Langstone FCERM Scheme Detailed Design

Community Participation Evenings July 2021 – Event Summary

COMMUNITY PARTICIPATION EVENINGS EVENT SUMMARY

Image 3 – Material options identified during the previous outline design.

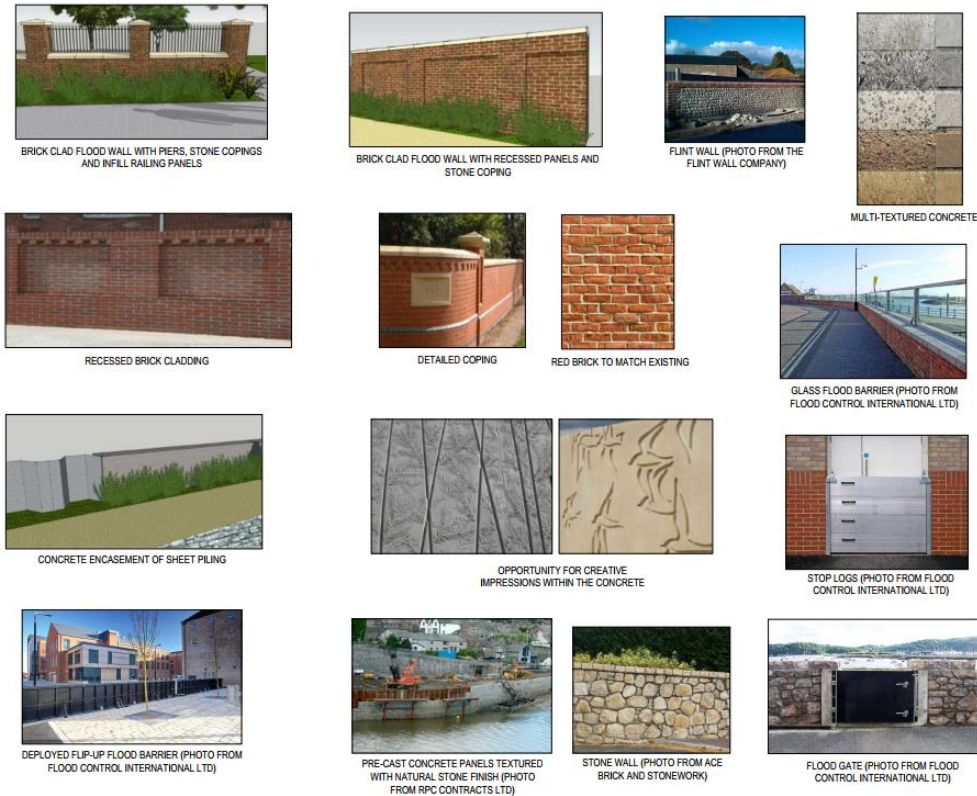
Q3.6) If you are proposing to cover up the existing wall with a new wall, how will this impact landscape/heritage? Is it possible to leave any of it exposed (especially the top?)

Q3.7) You mention cladding for the new flood wall. Do you have examples on what is possible here? Who will be consulted with to decide what this will look like?

A) Although it is possible to leave the top of the existing wall (i.e., above design crest level) exposed it would form a ledge in front of the existing wall which poses aesthetic impacts but also potential security issues for properties behind, so is not proposed to be taken forward. If a new wall is utilised in front of the existing, it will be clad to match as closely as possible the existing materials and appearance. We will take advice from our appointed Heritage Consultant as to the viable cladding options.

A) Cladding options will be further explored during the detail design and planning process. Relevant key stakeholders will be consulted including the community, Historic England, Havant Borough Council, the Conservation Officer, etc. Image 3 below sets out some of the material options identified during the previous outline design for this frontage. If a new wall is utilised in front of the existing, it will be clad to match as closely as possible the existing materials and appearance.

Coastal Partners have experience from other local schemes where heritage considerations were integrated into the look and feel of coastal defence, through liaison with Historic England <https://southseacoastalscheme.org.uk/old-meets-new-in-southsea-seawall-design>
